Proposal #26: 5880-03-63
Mauston – Wisconsin Dells
Water Street to Honeyair Street
USH 12
Juneau County

This is Addendum No. 01, which provides for the following:

ADDENDUM NO. 01

Addendum No. 01
 ID 5880-03-63
 Revised Sheet 5
 May 23, 2017

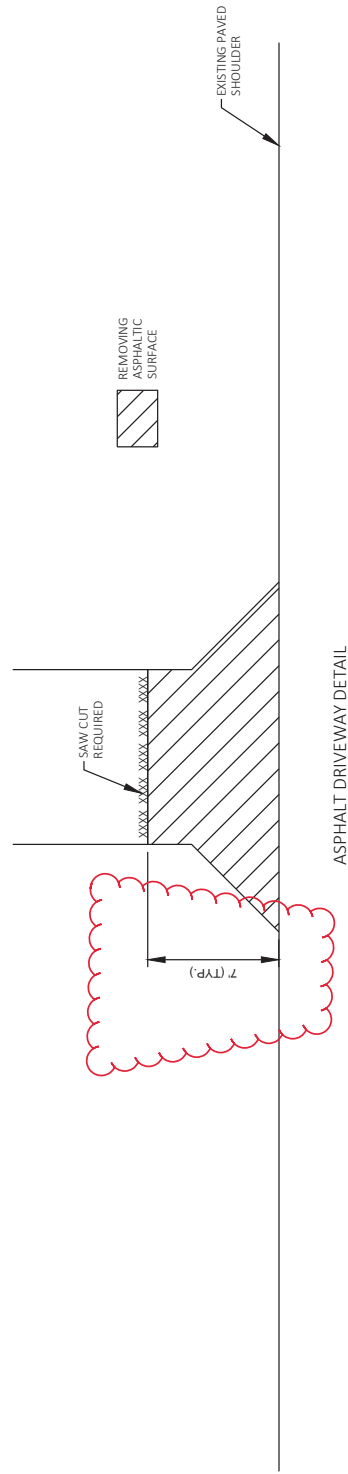
Revised Plan Sheets	
Plan Sheet	Plan Sheet Title (brief description of changes to sheet)
5	Construction Detail
32	Miscellaneous Quantities

Revised: 5 and 32.
